NAC-UMS RAI RESPONSE SUPPLEMENT 01

Docket No. 72-1015

NAC-UMS FSAR, Revision 25A

List of Changes for the NAC-UMS FSAR, Revision 25A

Figure 11.2.16-3 ANSYS Model for the PWR Fuel Rod Tip-Over Evaluation

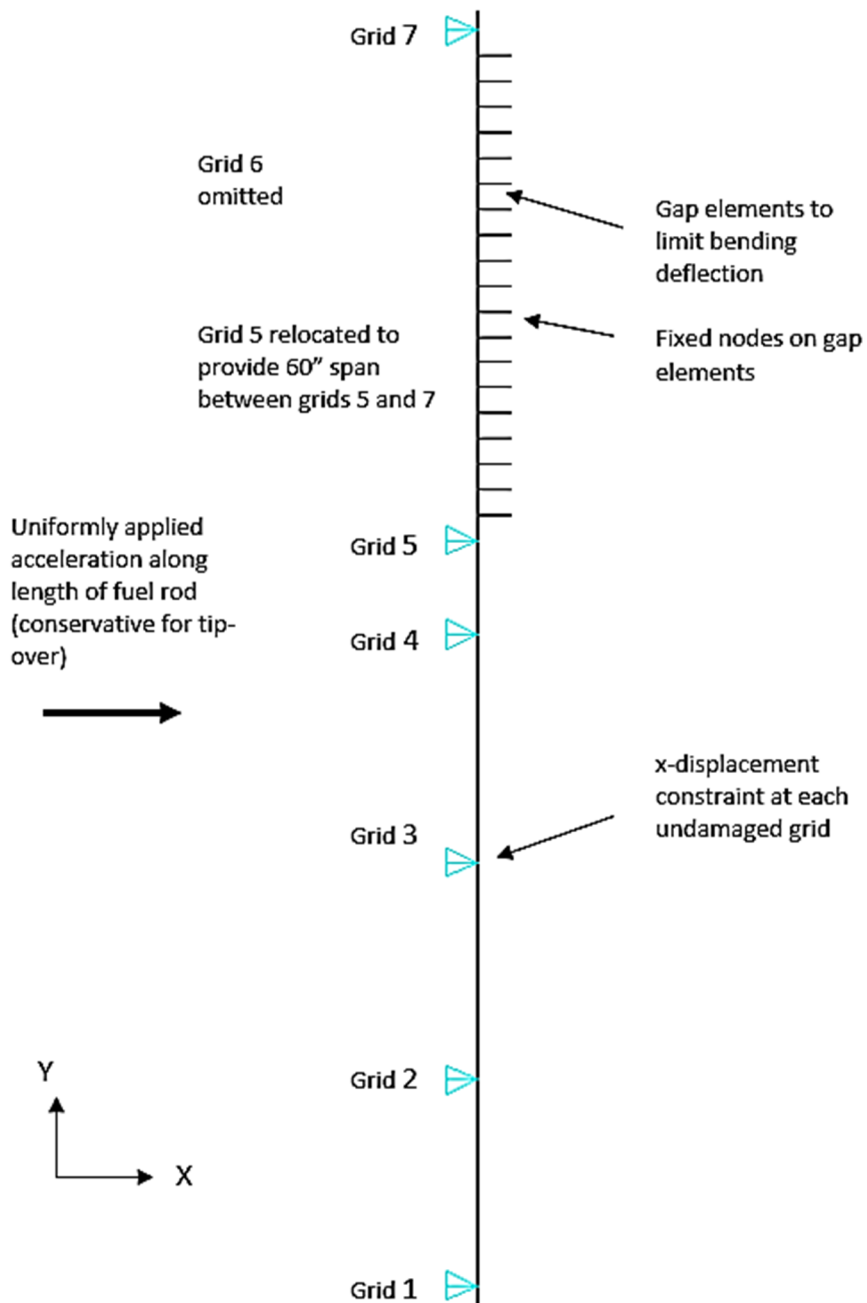
Chapter/Page/ Figure/Table	Source of Change:	Description of Change
<u>Chapters 1 thru 10 – no changes</u>		
<u>Chapter 11</u>		
Page 11-x	Revision 25A	Revised title of Table 11.2.16-1.
Pages 11.2.16-3 thru 11.2.16-5	Revision 25A	Revised text, where indicated.
Page 11.2.16-8	Revision 25A	Revised Figure 11.2.16-3.
Page 11.2.16-9	Revision 25A	Revised title of Table 11.2.16-1.
Pages 11.3-5	Revision 25A	Deleted Reference 67.
<u>Chapters 12 thru 13 – no changes</u>
